VEHICLE RECALL

G- 04304
June 2005

SUBJECT: SAFETY RECALL (U.S., EXPORT)
Drivers Seat Pedestal on certain FE Bus models built
between 03-12-1992 and 03-03-2004

Figure 1. Typical pedestal base involved in this recall. Location of "T" handle and bolt may vary by build date.

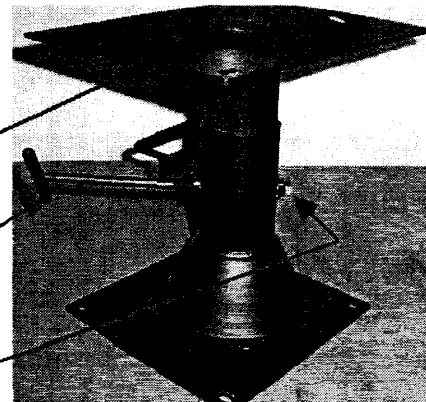
The seats involved in this recall are manufactured by CE White and are mounted on a pedestal type base only. The plate of the upper pedestal mounting of the driver seat pedestal, which provides the mounting surface for the seat, may develop cracks. These cracks could progress to the extent that the seat becomes unstable and distracts the driver, or in some cases the seat could separate from the base. This could possibly result in personal injury or death in the event of an accident.

Upper pedestal mounting that is mounted to the seat needs to be replaced.

1. Remove the four nuts that mount the seat adjusters to the plate.
2. Lift off the seat making sure that you clear any seat belt parts that may be guided by the seat.
3. Unscrew the "T" handle and guide bolt.
4. While holding the positioning lever in the most upright position, remove the upper pedestal mounting.
5. Insert the new upper pedestal, making sure the guide slot (long vertical slot in the tube) is inline with the guide bolt.
6. Screw the guide bolt back into place.
7. Reinstall the seat assembly removed in step 2, using the nuts removed in step 1. **Make sure** that the seat belt is placed back in the guide if available. The nuts should be **torqued** to 16 to 18 LbF-Ft (21.7 Nm to 24.4 Nm) if dry and 12 to 14 LbF-Ft (16.3 to 18.9 Nm) if oiled.
8. Adjust the seat to desired height and tighten the "T" handle to secure the seat position.
9. Destroy the removed upper pedestal.
